*PCN No.: PCN-0084

*Subject: Change TVS Die size from 56mil to 60mil

*Affected Family: DO-219(F1A)

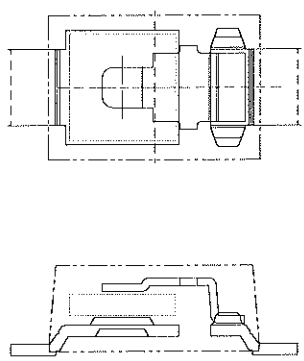
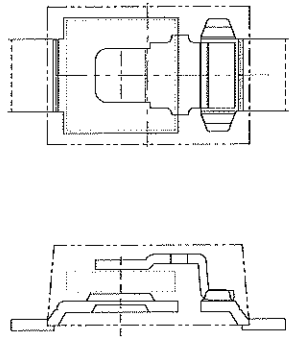
Change Item	<input checked="" type="checkbox"/> Material <input checked="" type="checkbox"/> Design <input type="checkbox"/> Process <input type="checkbox"/> Others	
Impact Item	1. Product P/N : <input type="checkbox"/> Yes <input checked="" type="checkbox"/> No 2. Marking : <input type="checkbox"/> Yes <input checked="" type="checkbox"/> No	3. Label : <input type="checkbox"/> Yes <input checked="" type="checkbox"/> No 4. Other items : <input type="checkbox"/> Yes <input checked="" type="checkbox"/> No
Other Related Item	1. BOM changing 2. Inner structure changing	
Change Purpose	1. Quality improvement --- IPP From 100%IPP capability to 120% lpp capability	
Description of Change	Before Change	After Change
	<p>Die size: 56mil & Inner structure</p> 	<p>Die size:60mil & Inner structure</p>
